Technical Service Bulletin: tsb100129

Cylinder Head Changes

This service/parts topic provides a history of the changes made to the QSK45/60 cylinder head. Also provided is updated parts information, which will be required during in-shop rebuilds of QSK45/60 cylinder heads.

Fig. 1, Rotator Installed over the Valve Guide with the Spring-Pilot Flange Face-up

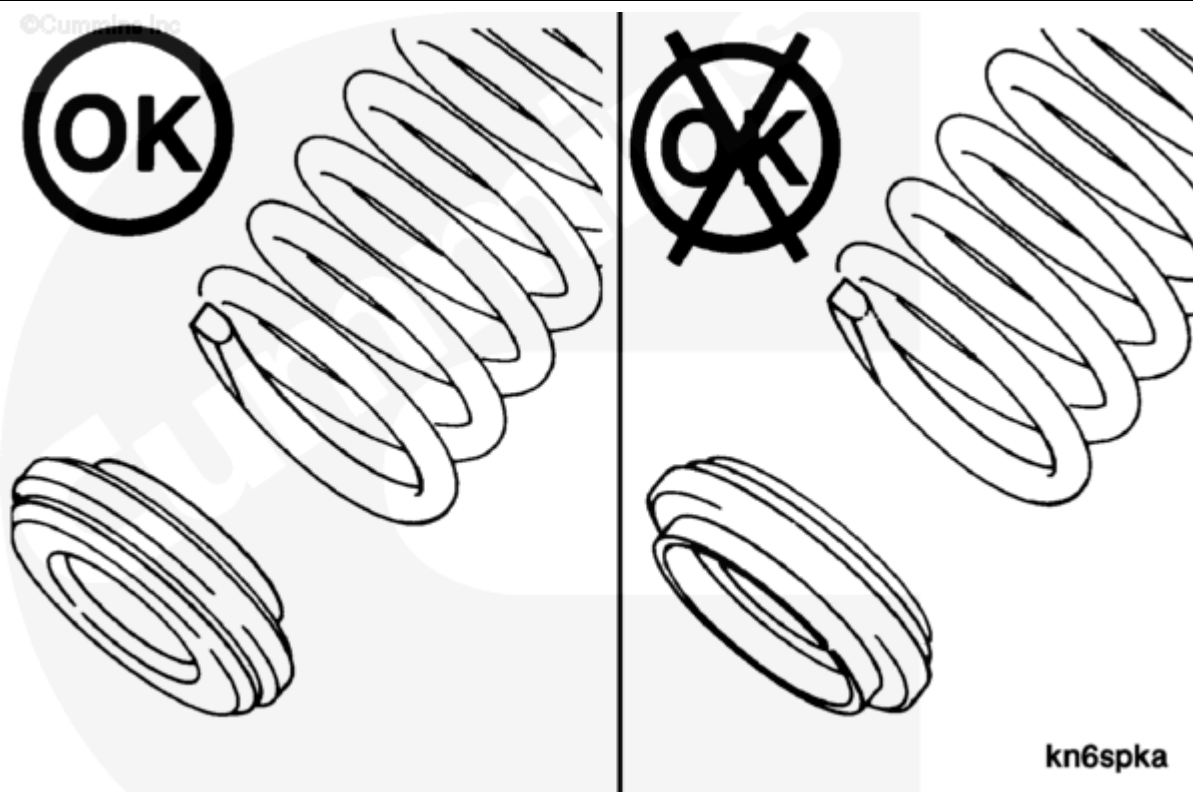
The valve spring rotator is designed to decrease valve guide wear. It lets the valve spring rotate the valve naturally as the valve opens and prevents the valve from rotating back into the original position. The valve spring rotator fits between the cylinder head and the valve spring and adds approximately 10.3 mm [0.406 in] to the valve spring assembly height. When installing a QSKV valve spring rotator, Part Number 3085961, a rotation check of the valve spring rotator in the free state can **not** be done.

When turning the valve spring rotator by hand, it can be difficult to turn or can **not** turn at all. Even if a valve spring rotator is difficult to turn by hand, it is **not** "seized"; such difficulty is common. Slight dimensional variations of components can make some valve spring rotators seem tight; but when the valve spring load is applied, the valve spring rotator compresses, which provides more clearance between the collar and the body of the valve spring rotator, allowing it to rotate freely.
